Stakeholder Comments Template

Hybrid Resources

Submitted by	Organization	Date Submitted
Mike Pezone (415) 973-6093 Jared Rist (415) 973-3764	Pacific Gas and Electric Company	8/14/2019

Figure 1: Bidding Interval Example

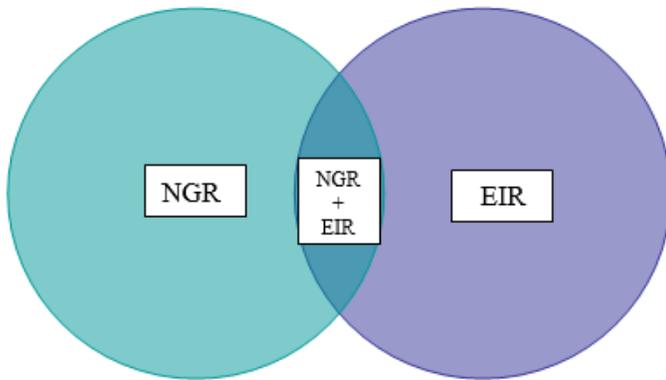
Information Visualization. The CAISO may consider representing some information presented in the Issue Paper as Venn diagrams instead of tables. This may help stakeholders visualize and comprehend the material more easily. Included below are two examples:

Figure 1 shows how a hybrid resource can be represented by three configurations in a given market or bidding interval

Figure 2: Plant Operation Example

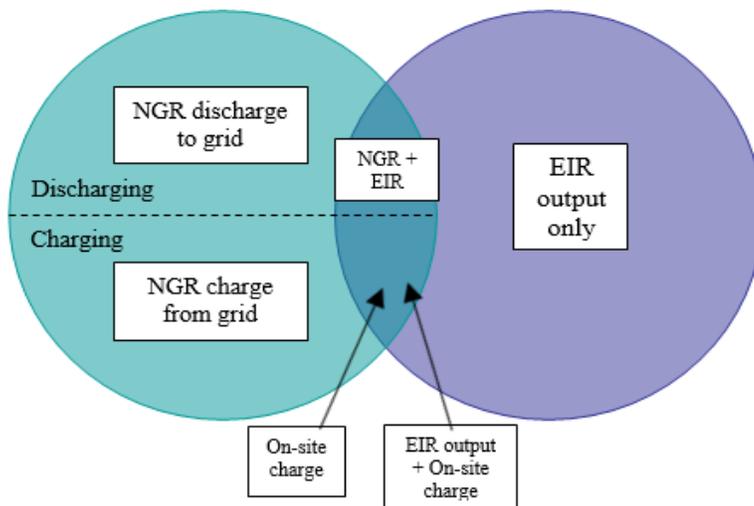
Figure 2 shows the potential operational configurations of a hybrid resource at the plant level.
